**ADDENDUM NO. 03
September 26, 2022**

**WINDSONG ELEMENTARY SCHOOL ADDITION & RENOVATION ISSUE FOUR PROPOSAL
FOR FRIENDSWOOD I.S.D.**

Prepared by: PBK
11 Greenway Plaza, 22nd Floor
Houston, TX 77046-1104
PBK Project No: 20380

05 SECTION AT BLDG NORTH COVE
1/2" = 1'-0"

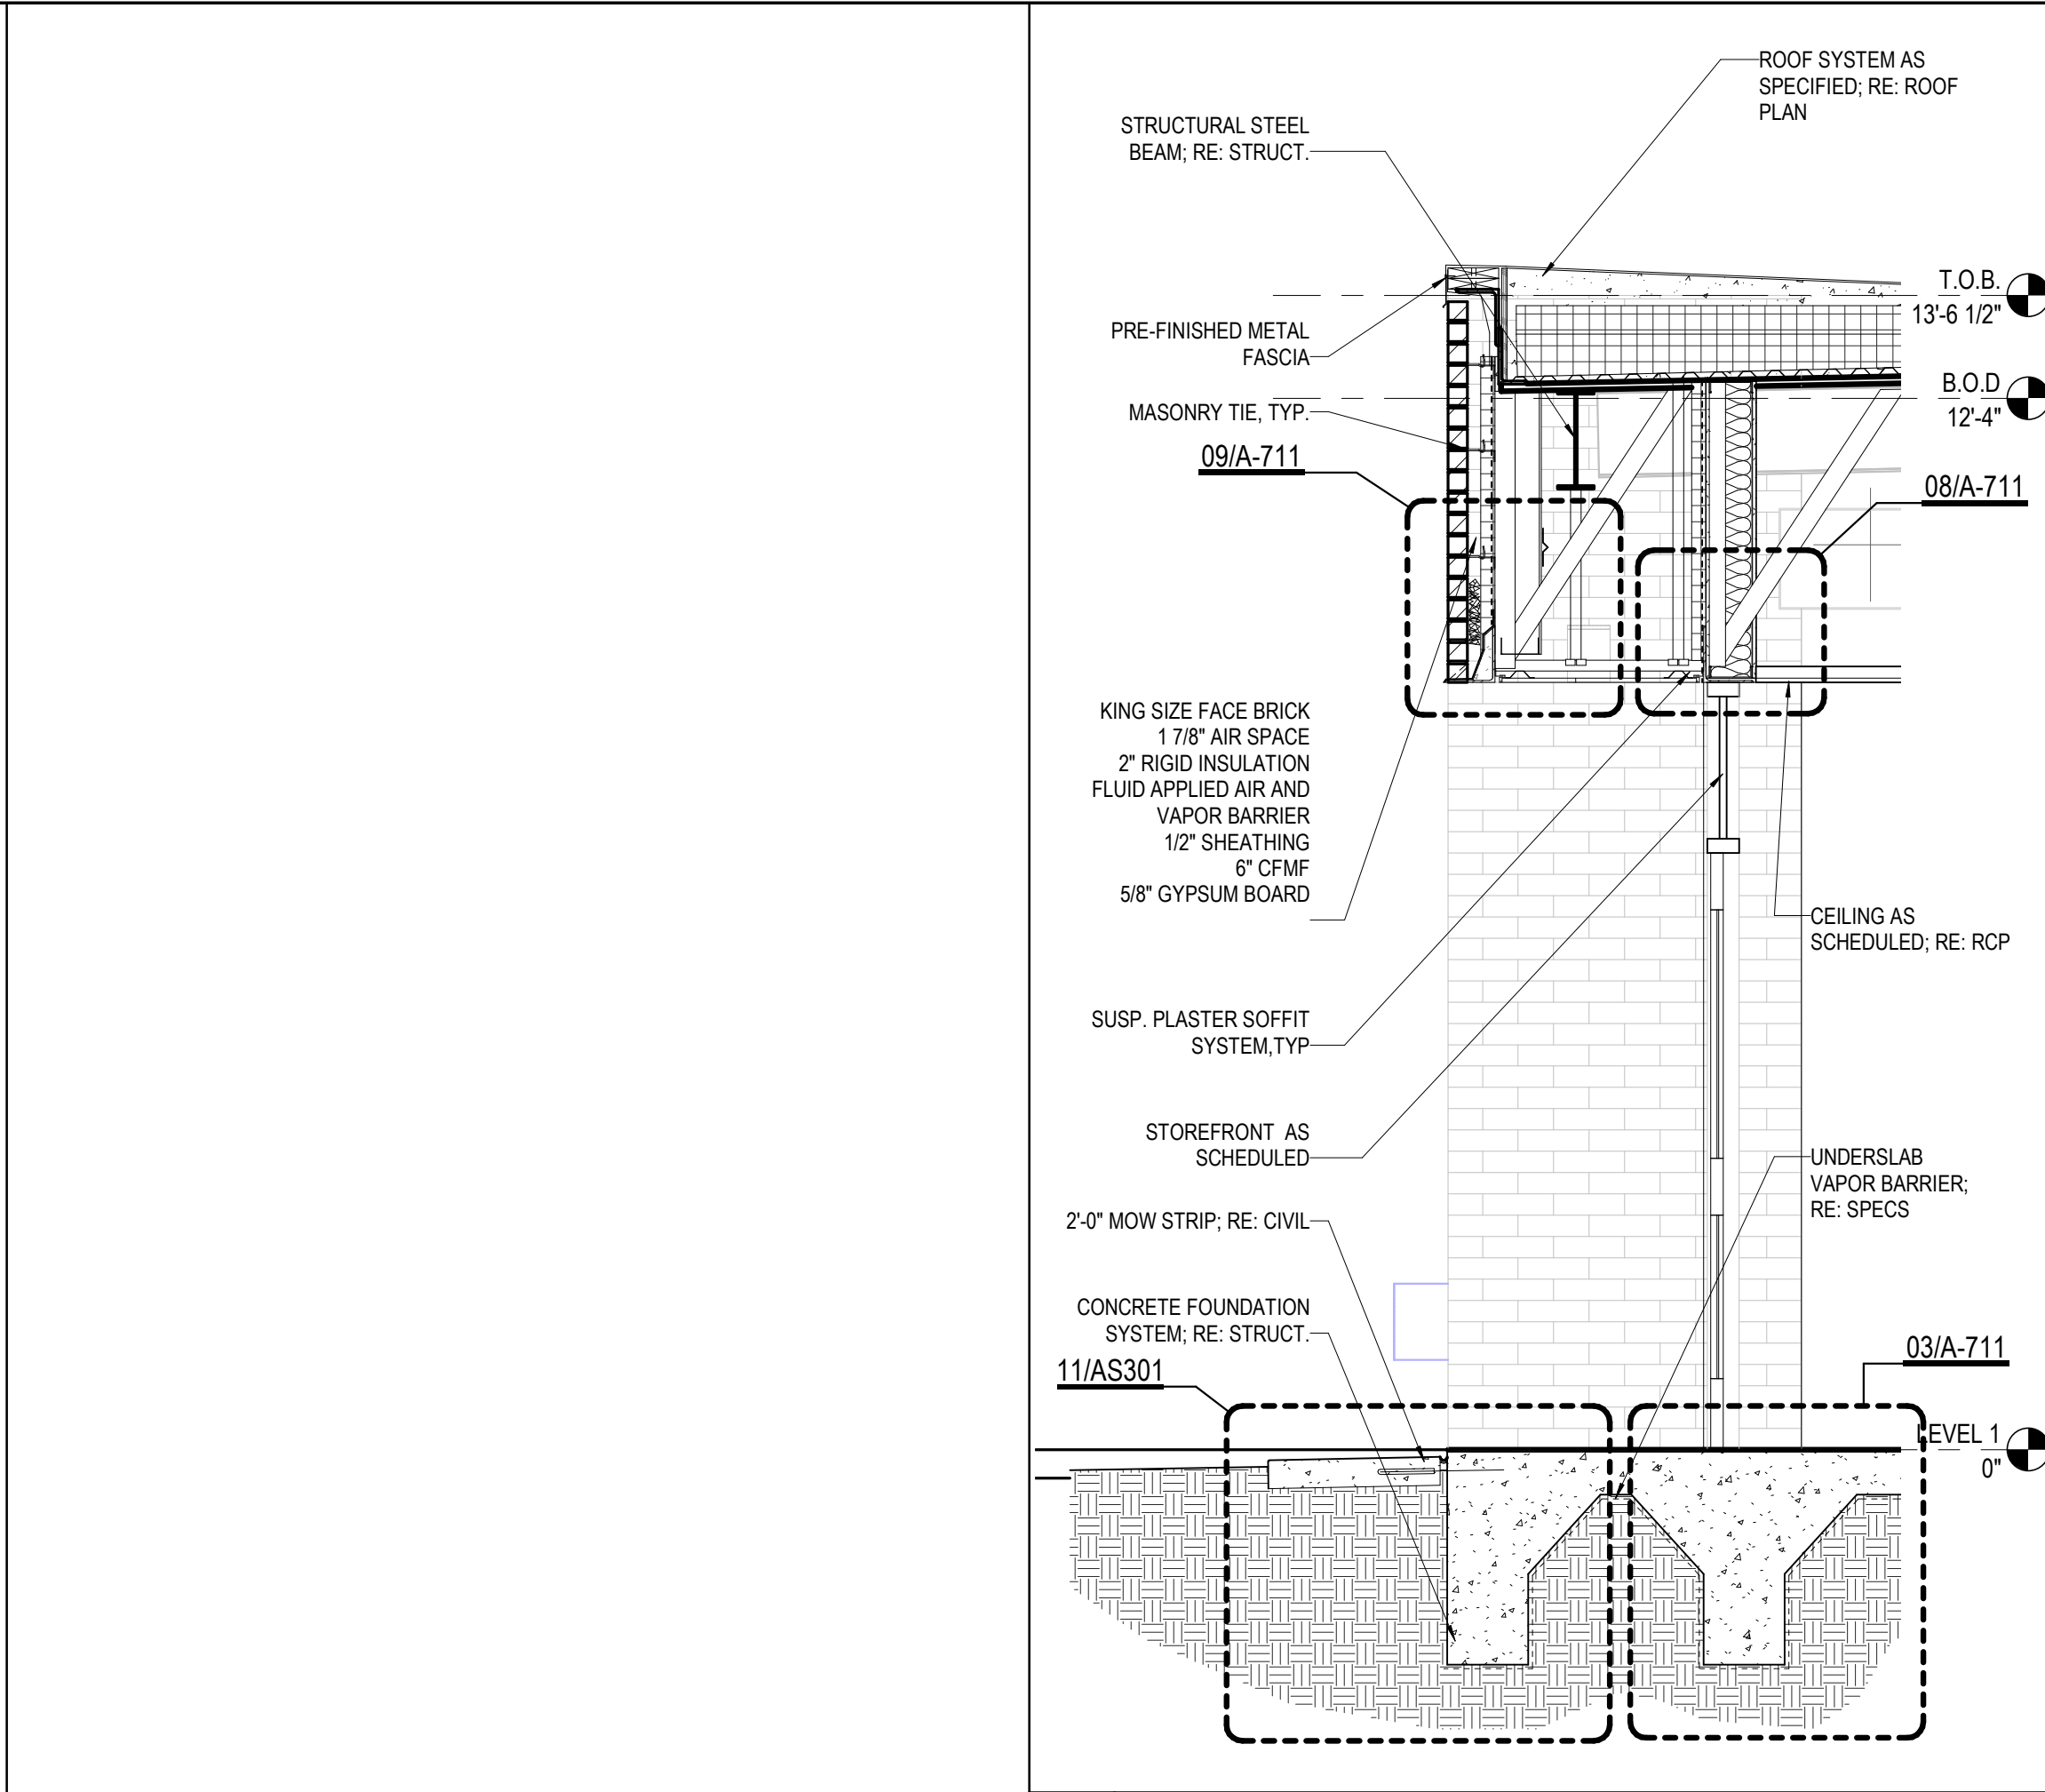
- Item No. 68 **A-402 Enlarged Interior Elevations**
 A. Detail 05: Added drinking fountain, tile, and clarifying notes, refer to attachment.
 B. Detail 08: Revised callouts for tackable surface, added corner guard callout, and revised door graphic, refer to attachment.

C. Added elevation 15 in it's entirety.
- Item No. 69 **A-602 Wall Sections:** Revised sections 01 and 06, refer to attachment.
- Item No. 70 **A-701 Plan Details**

A-711

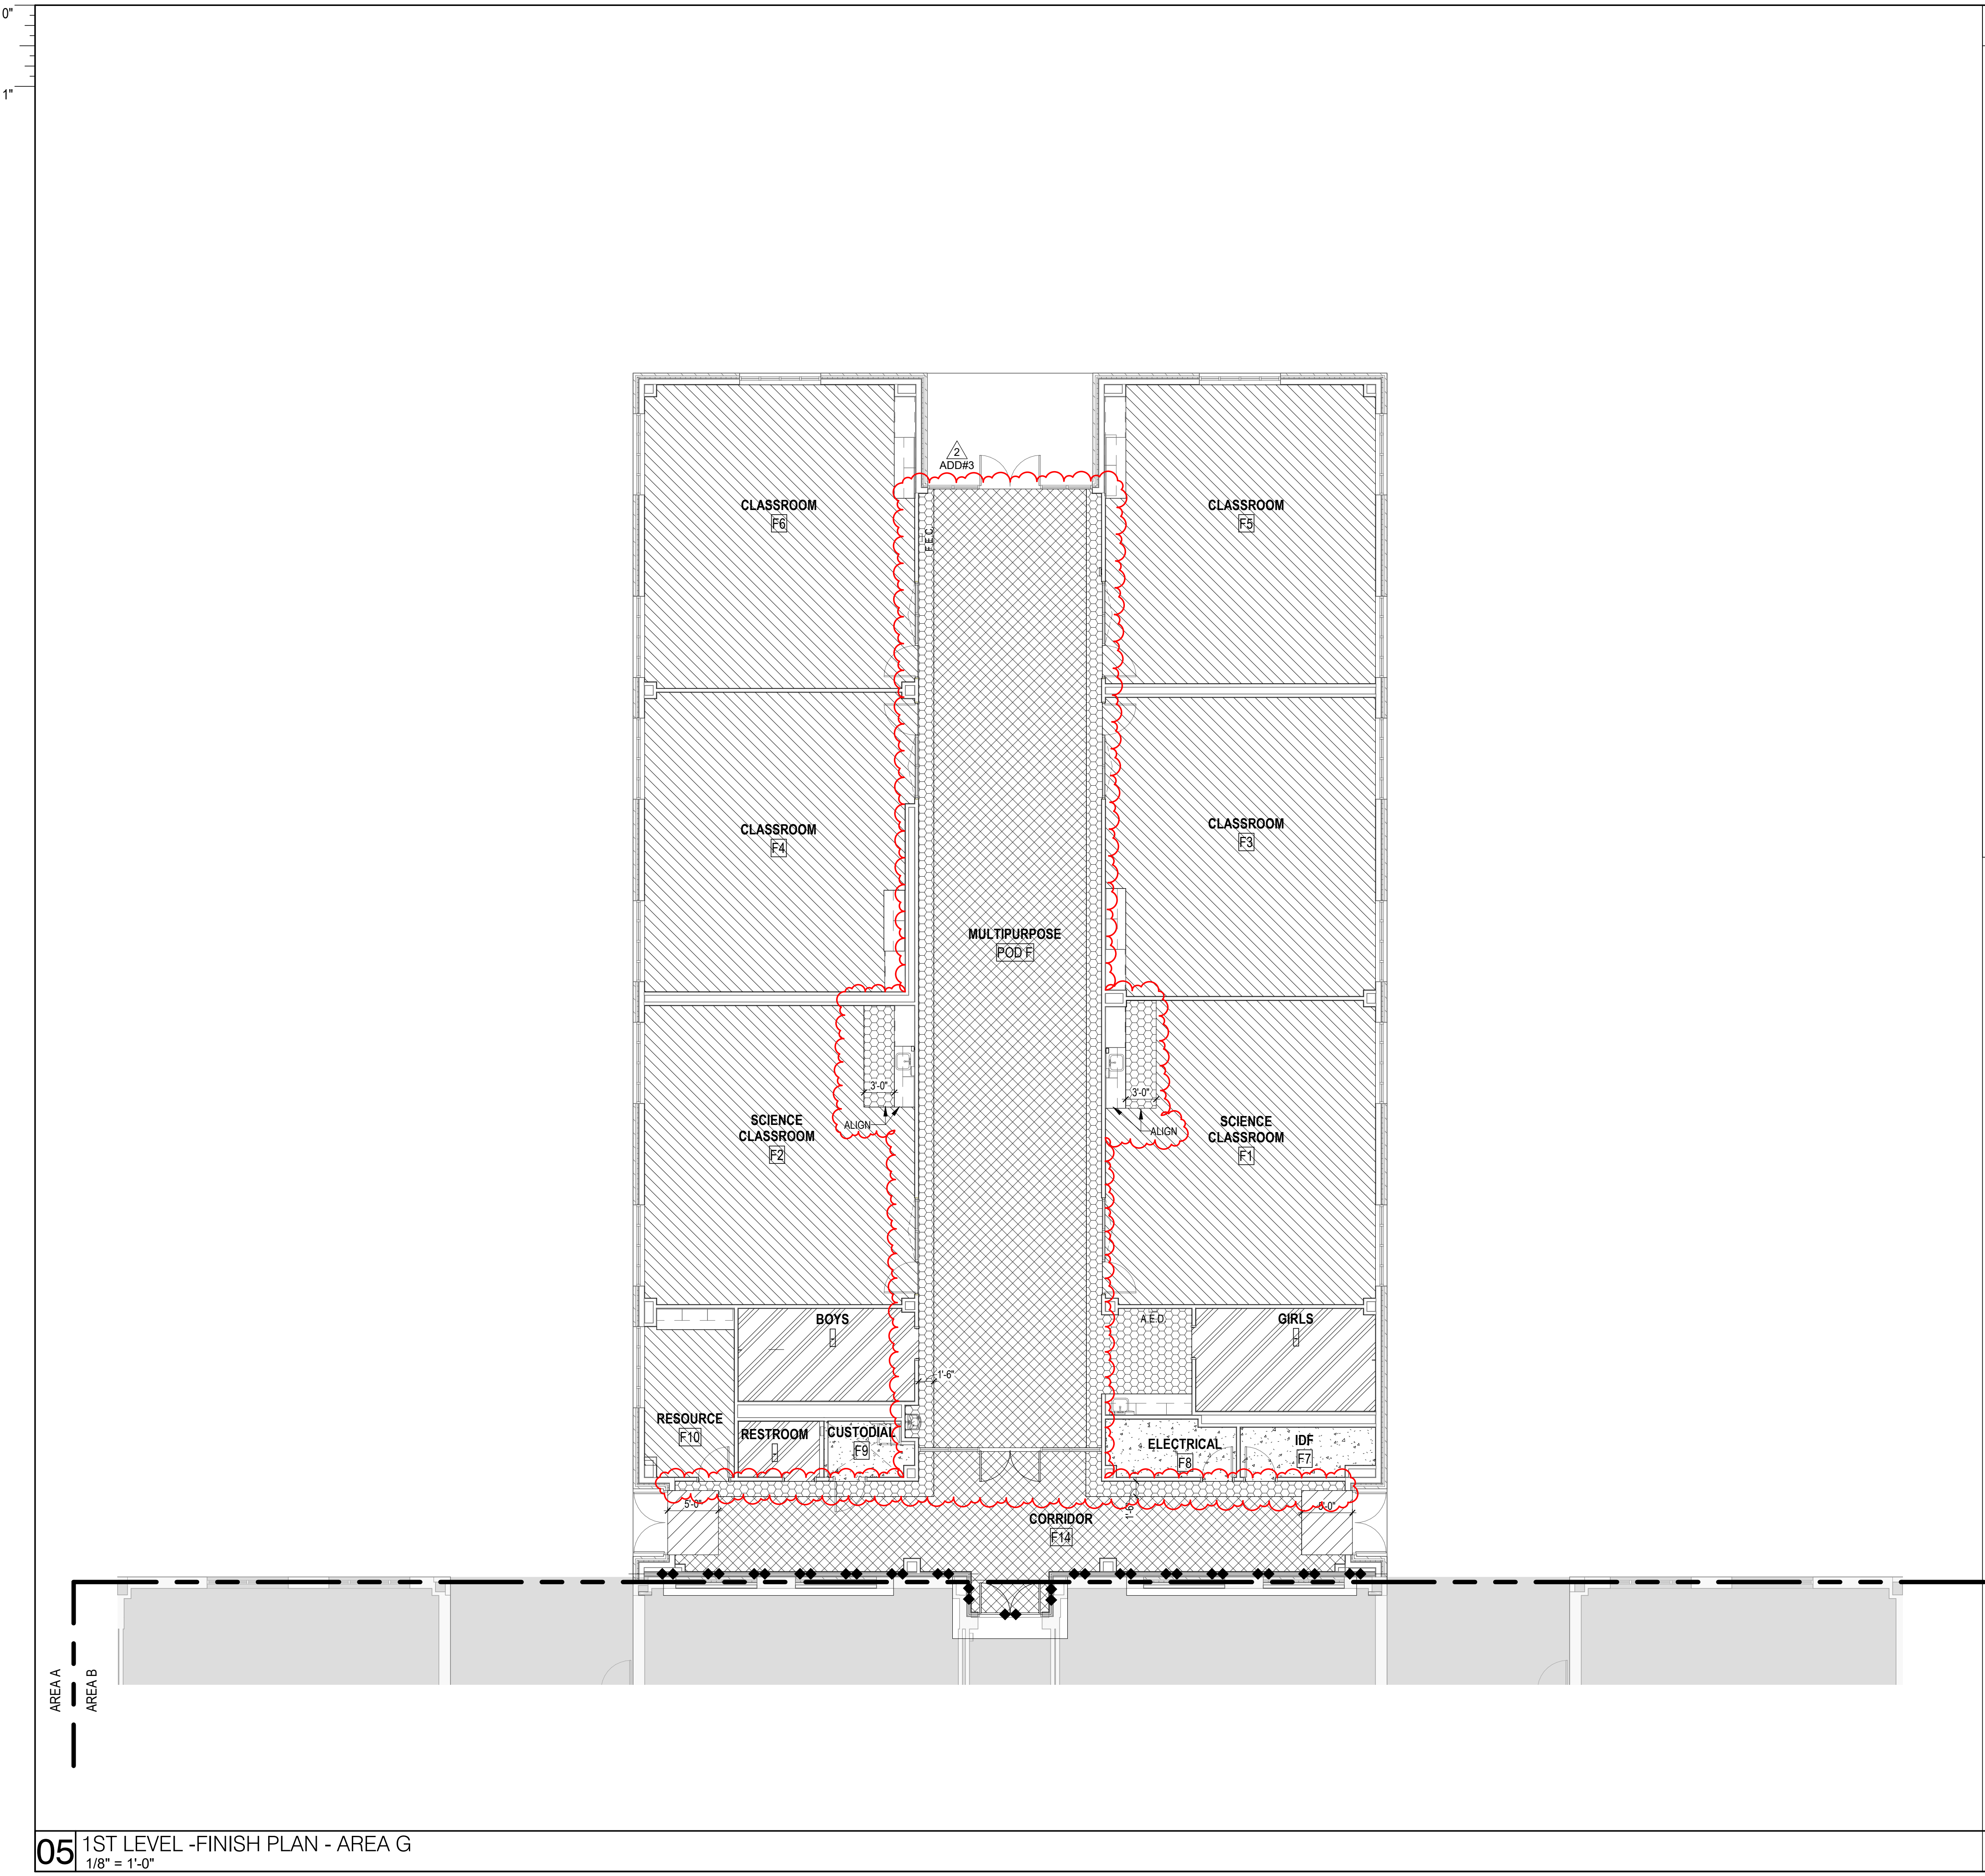
A. Added detail 06 in it's entirety, refer to attachment.
 B. Revised detail 02 and 11, refer to attachment.
- Item No. 72 **AF101G 1ST Level – Finish Plan – Area G**

AF101G

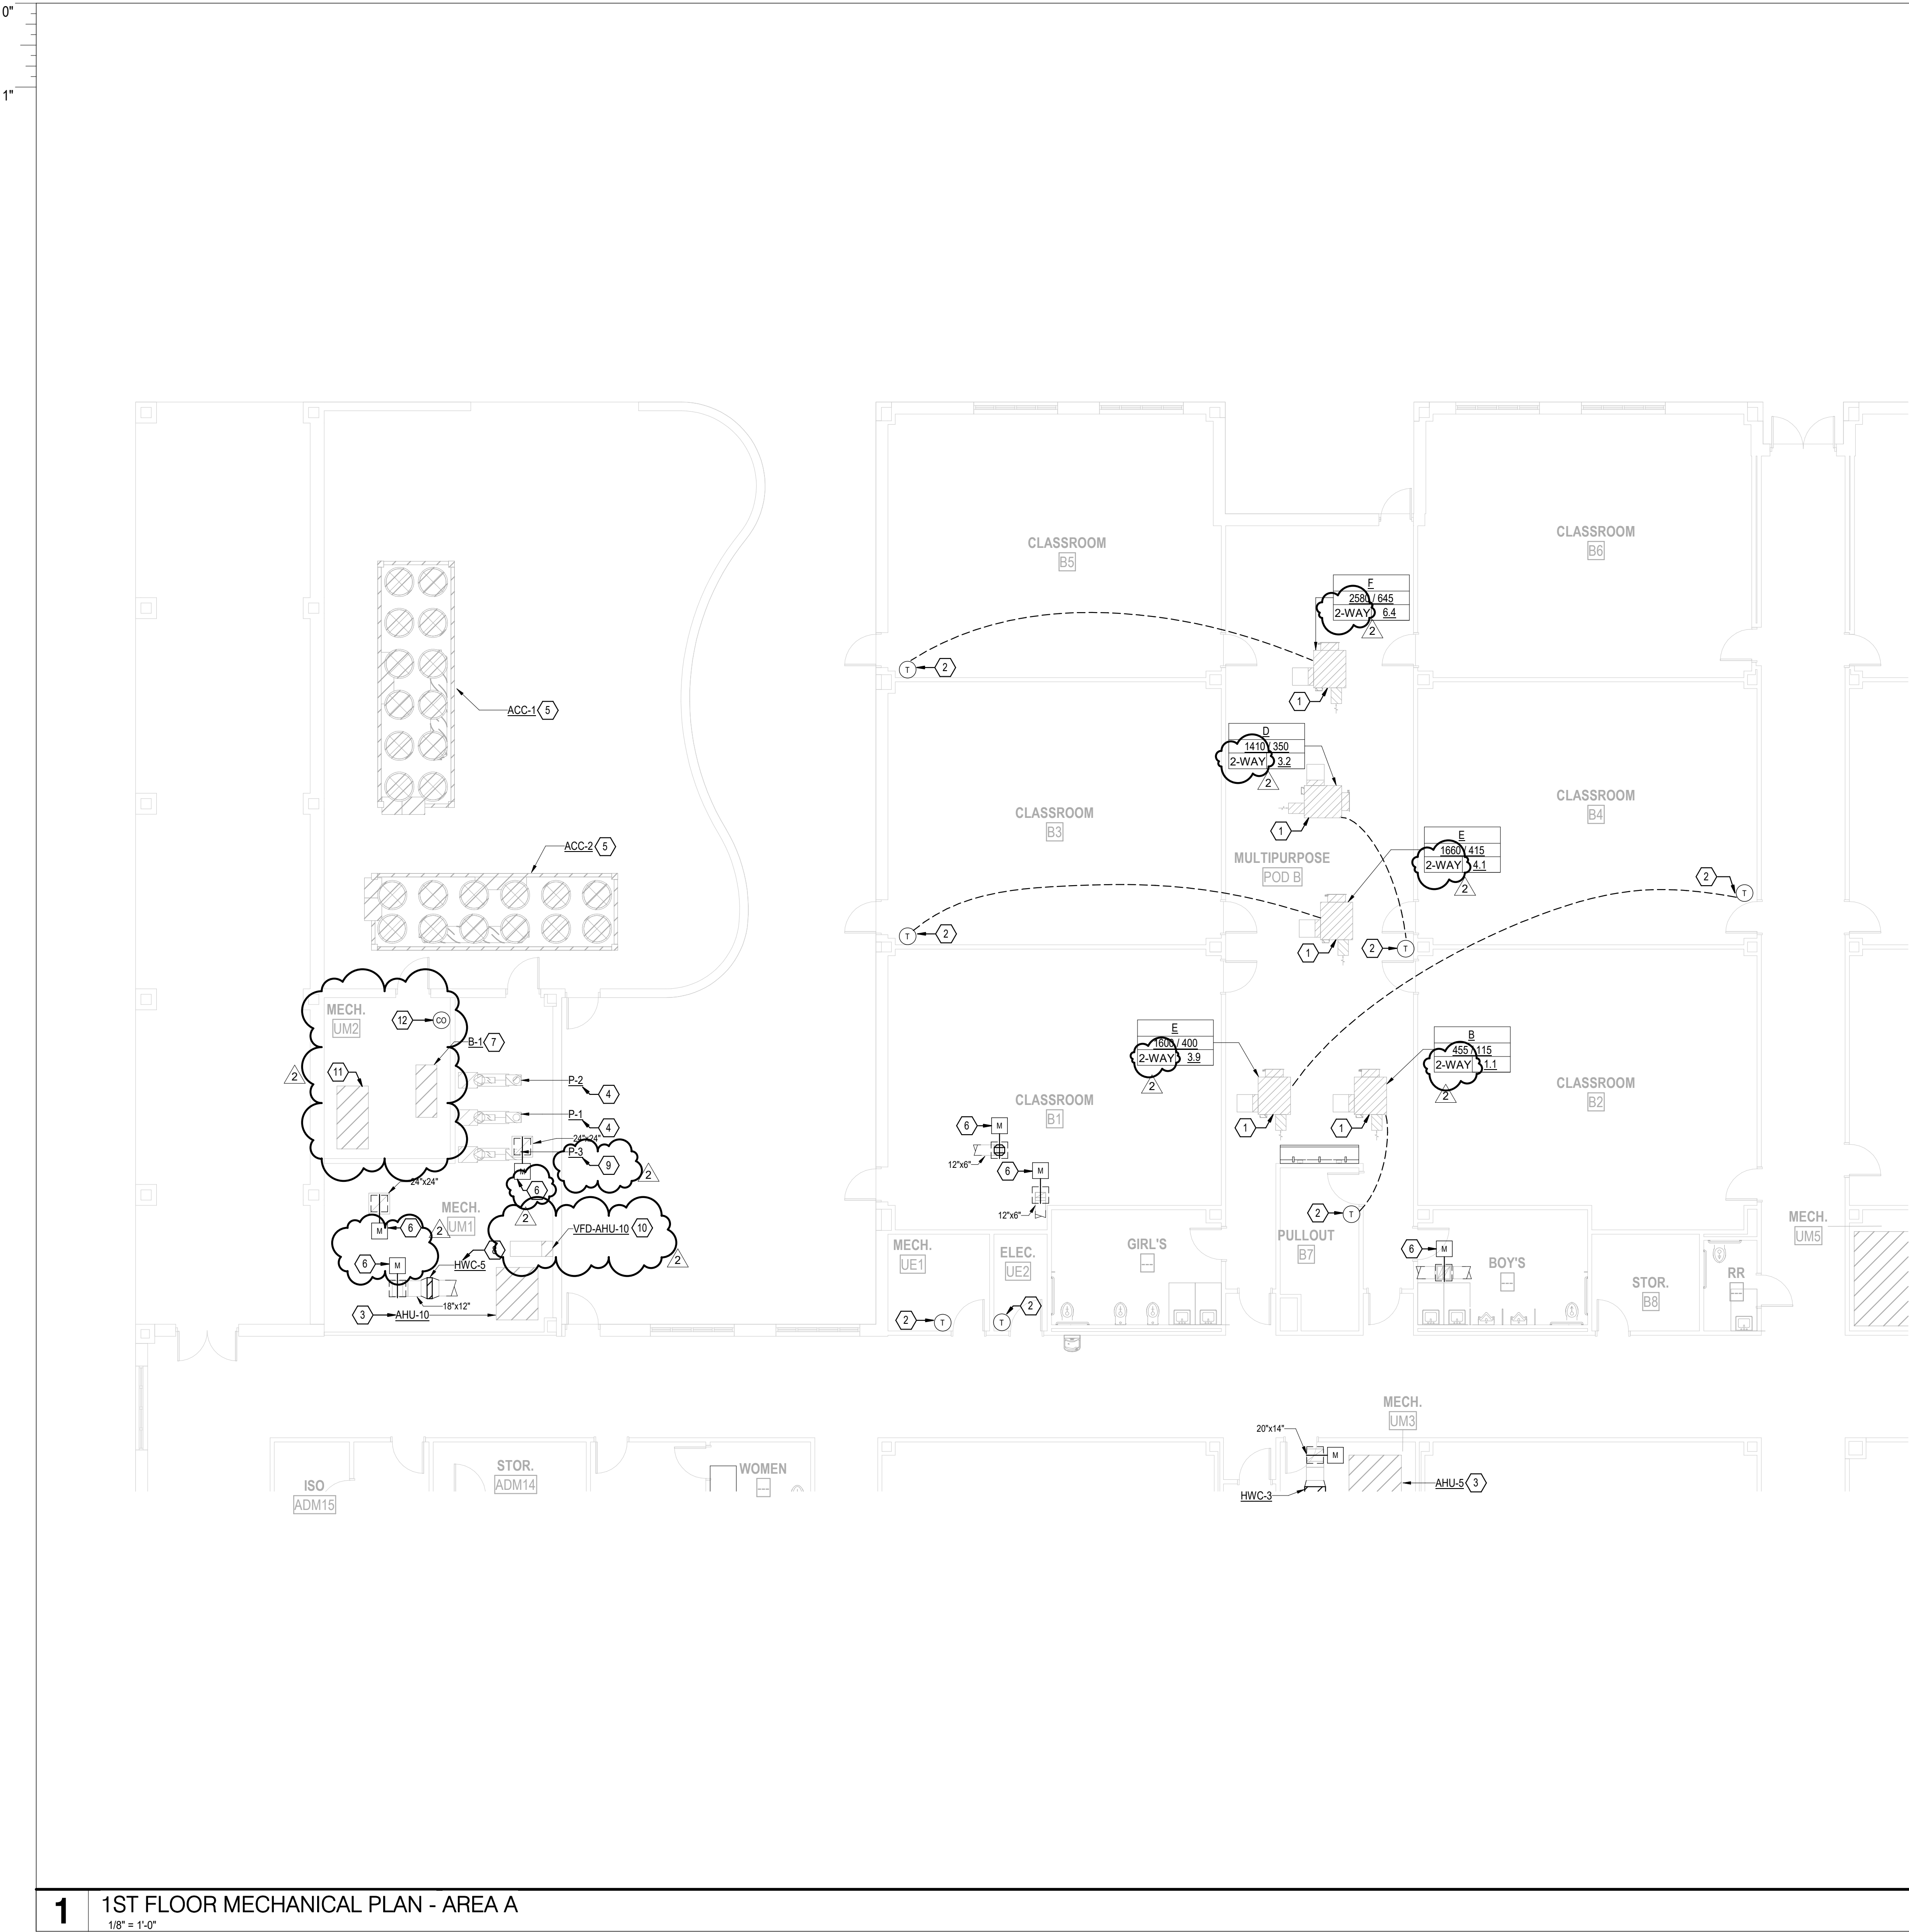
A. Revised LVT flooring pattern and locations, refer to attachment.
 B. CPT-2 removed.
- Mechanical**
- Item No. 73 **SHEET M-101A – 1ST FLOOR MECHANICAL FLOOR PLAN – AREA A**
